Addendum No.1

Maider Road Waterfront ERP Site Remediation

Addendum No. 1 Issued: 03/26/2021

The purpose of this addendum is to respond to questions following the Pre-Bid Walkover on 03/17/2021, as well as to amend certain bid documents.

WETLAND
RESTORATION
NOTES

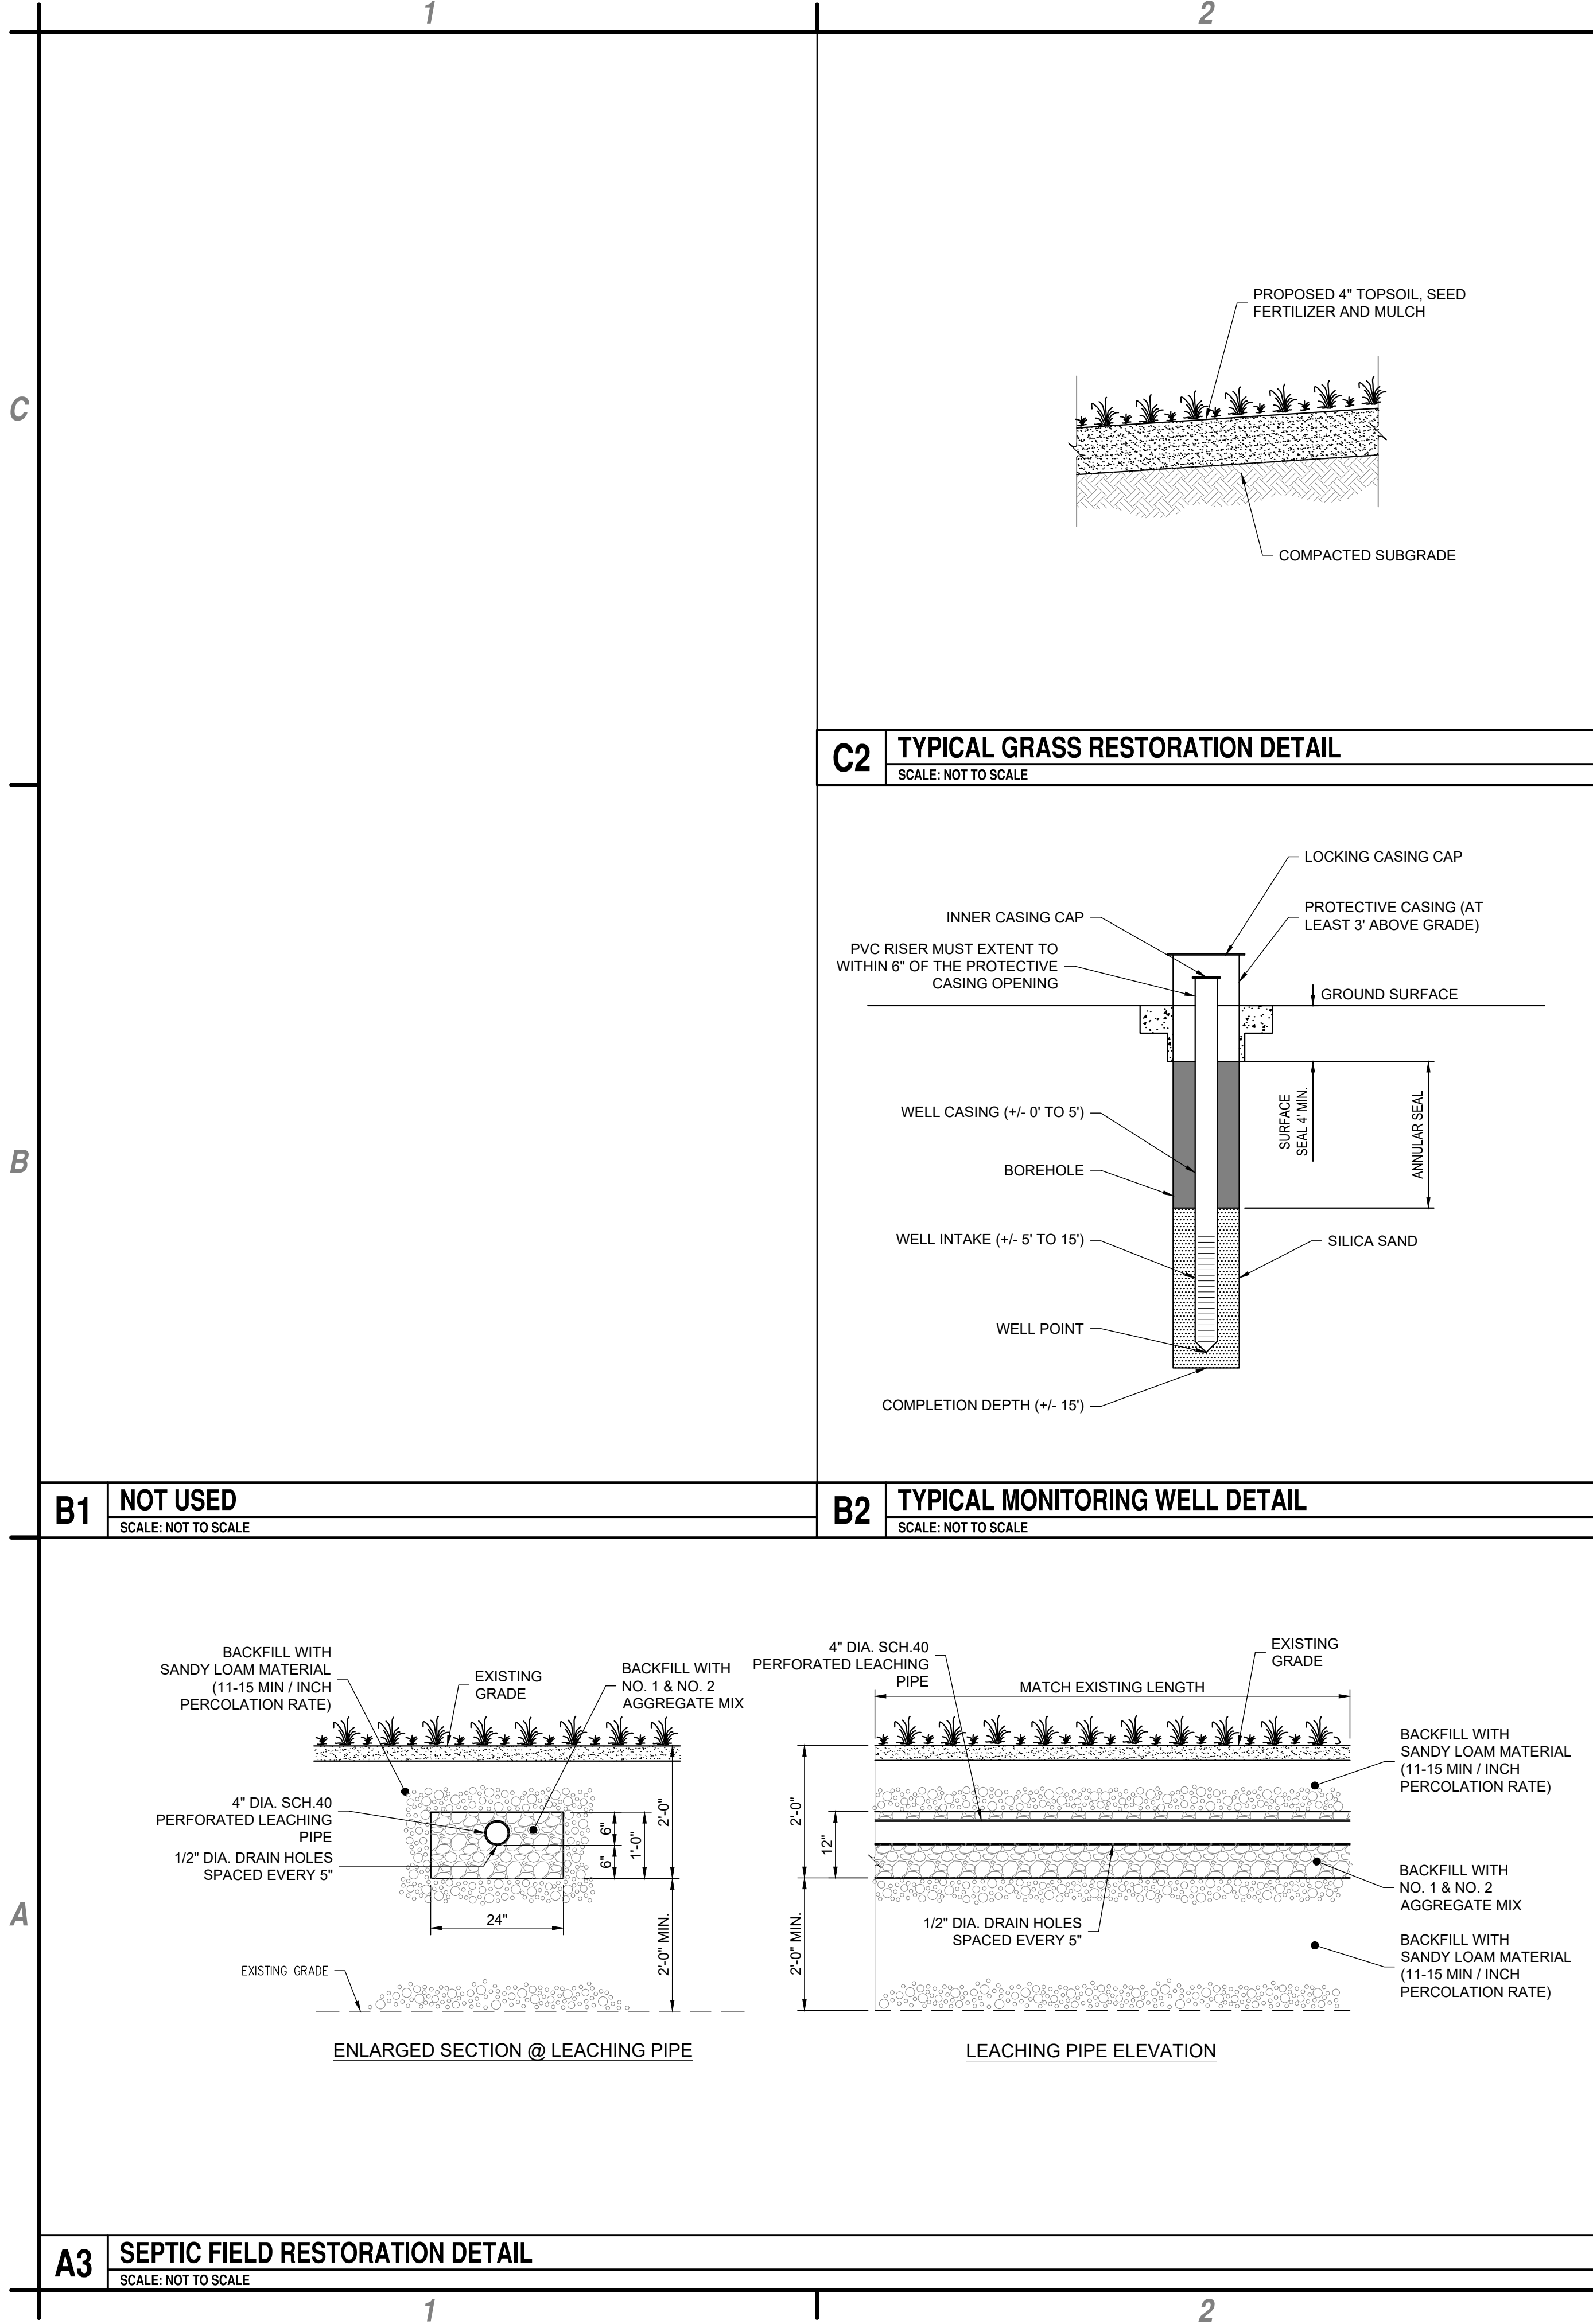
Q: For the Wetland Restoration (Bid Form Item #42), on drawing C-106, is there a specific seed mix and/species list for the mix to be installed in “wetland seeding areas?”

Q: Is there a warranty period for the planted material? If so, what are the survival/cover requirements and for what length of time?

A: Attached are the up to date Wetland Restoration Plan Sheets. On sheet C-106 there are 3 wetland seeds mixes listed and only one of the seed mixes needs to be installed in the wetland restoration areas.

A: Attached are the up to date Wetland Restoration Plan Sheets. On sheet C-106 in these plans there is a discussion of warranty period for the planted material along with survival cover requirements and length of time.

C-500

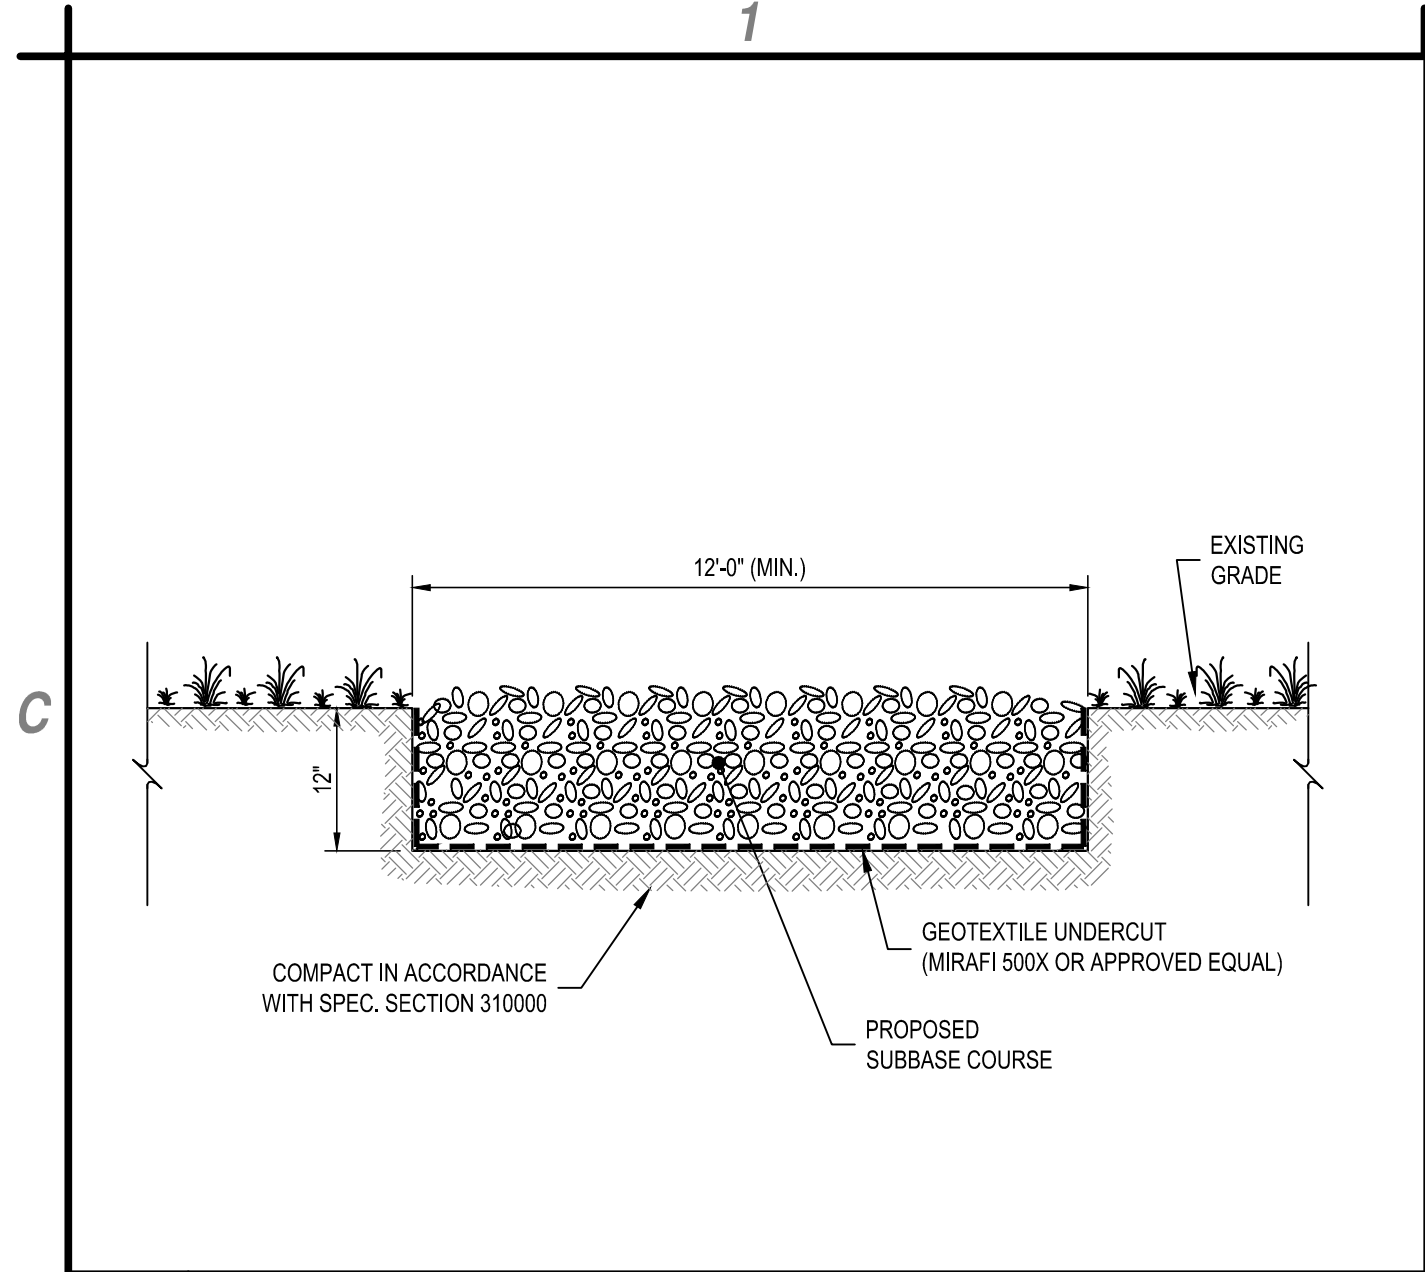
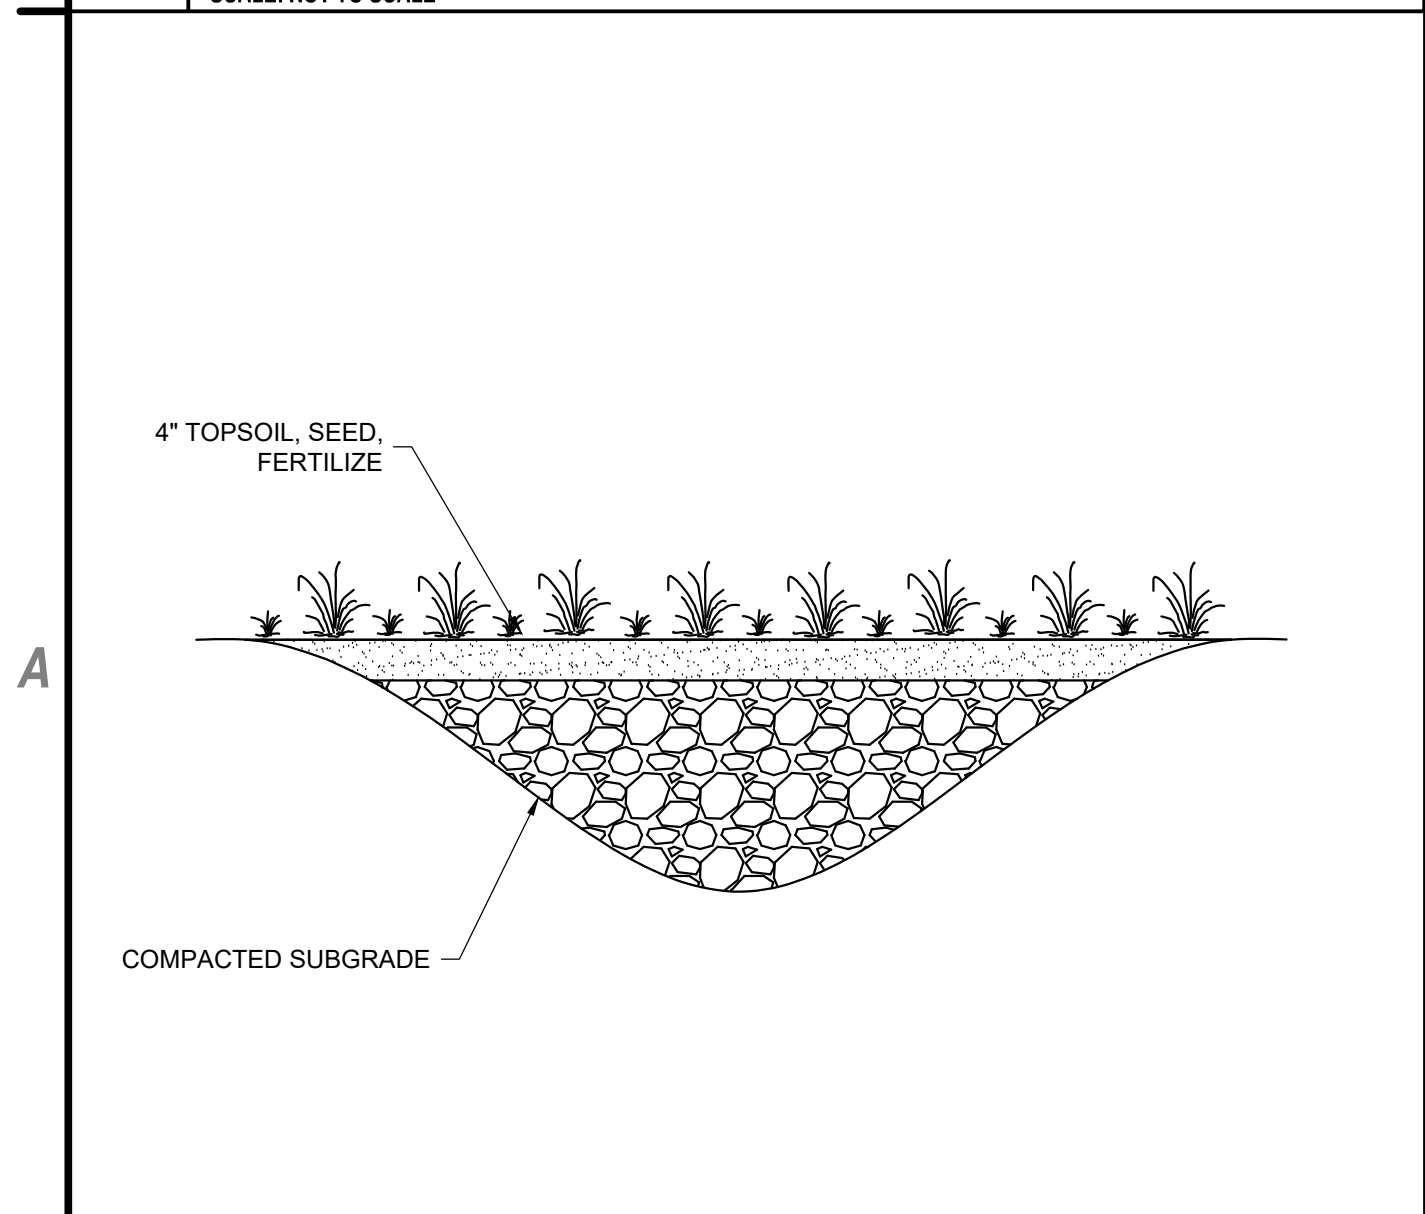
- C-500 was modified to remove the turbidity curtain detail and stabilized construction entrance detail.
 - The updated Wetland Restoration Plans (C-104 to C-106) are provided.
